DEFENSE LOGISTICS AGENCY
LAND AND MARITIME
P.O. BOX 3990
COLUMBUS, OHIO 43218-3990

SUBJECT: Initial Drafts of:

MIL-PRF-49470D (Capacitor, Fixed, Ceramic Dielectric, Switch Mode Power Supply (General Purpose and Temperature Stable), Standard Reliability and High Reliability, General Specification for)

MIL-PRF-49470DC

FIGURE 1. Dielectric parameters.

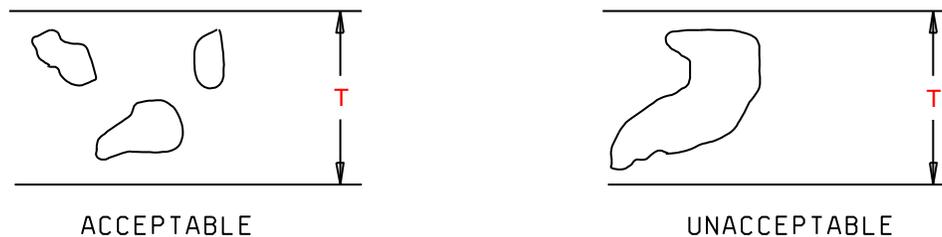
3.5.1 Dielectric parameters. Capacitors supplied to this specification shall have a minimum dielectric thickness (T) of 0.8 mil for 25 volt and 50 volt rated capacitors or 1 mil for capacitors with ratings above 50 volts. Dielectric thickness is the actual measured thickness of the fired ceramic dielectric layer. Voids, or the cumulative effect of voids, shall not reduce the total dielectric thickness by more than 50 percent (see figure 1).

FIGURE 3. Terminal strength - direction of applied force.

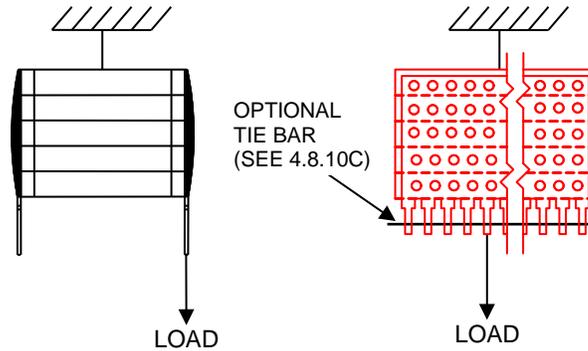
- e. Direction of applied force: The point of application of the force and the force applied shall be in the direction of the axes of the terminations, as shown in [figure 3](#).
- f. Examination after test: Capacitors shall be visually examined for evidence of loosening or rupturing of the terminals.
